CANNONDESIGN

Field Report

DATE	Sept. 16, 2016	**REPORT NO.**	**002**
PROJECT:	Webster University Interdisciplinary Science Building 8274 Big Bend Blvd. Webster Groves, MO 63119	**DATE OF VISIT:** **TIME:** **WEATHER:**	Sept. 06, 2016 3:50 pm 93°F Sunny
PROJECT #	004560.01		
PRESENT AT SITE:	Kelvin Patel (CD), Jason Szachnieski (Paric)

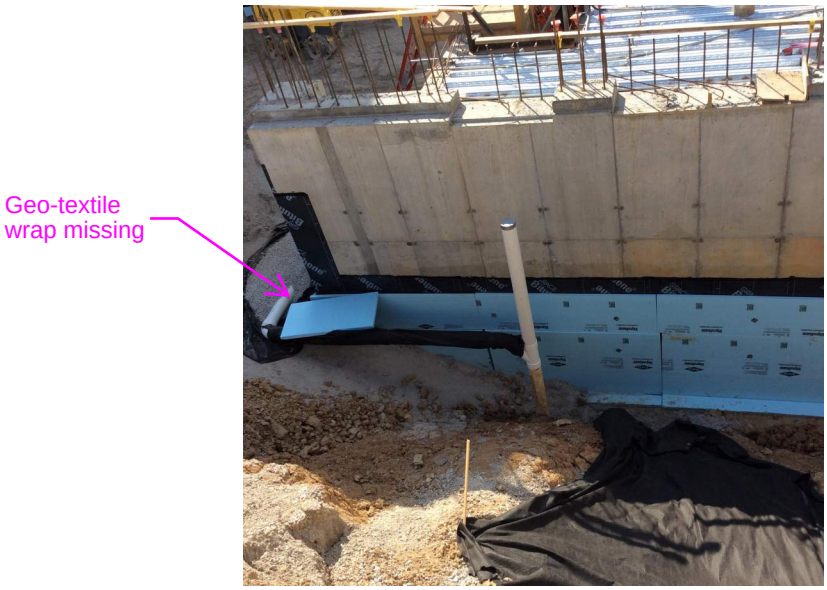
5. Observed backfill in process at corner of grid C.3 and 8, the geo-textile wrap on drain-tile seem to be missing.
ACTION: Contractor to provide geotextile wrapped draintile as directed in RFI 258.

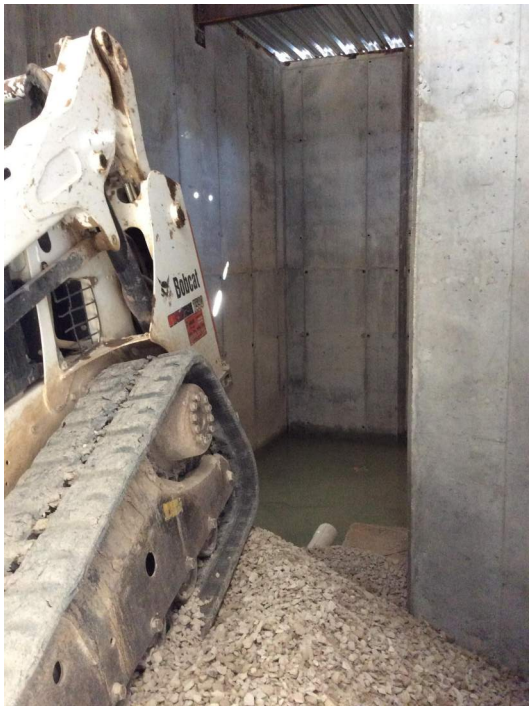
6. Elevator pits at level 00 were filled with water.
ACTION: Dewatering to be done per specifications.

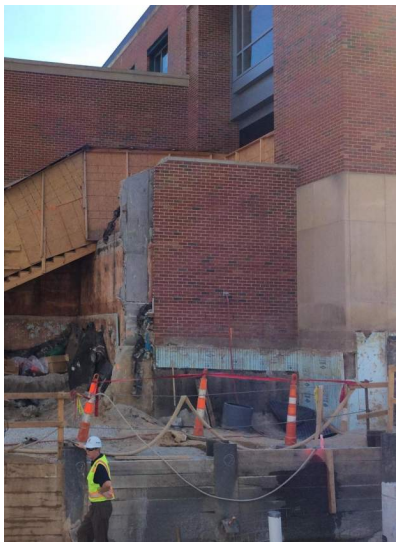
7. All the waterproofing at the foundation walls of existing EAB on the north & south side is damaged.
ACTION: Waterproofing to be restored properly prior to backfill.
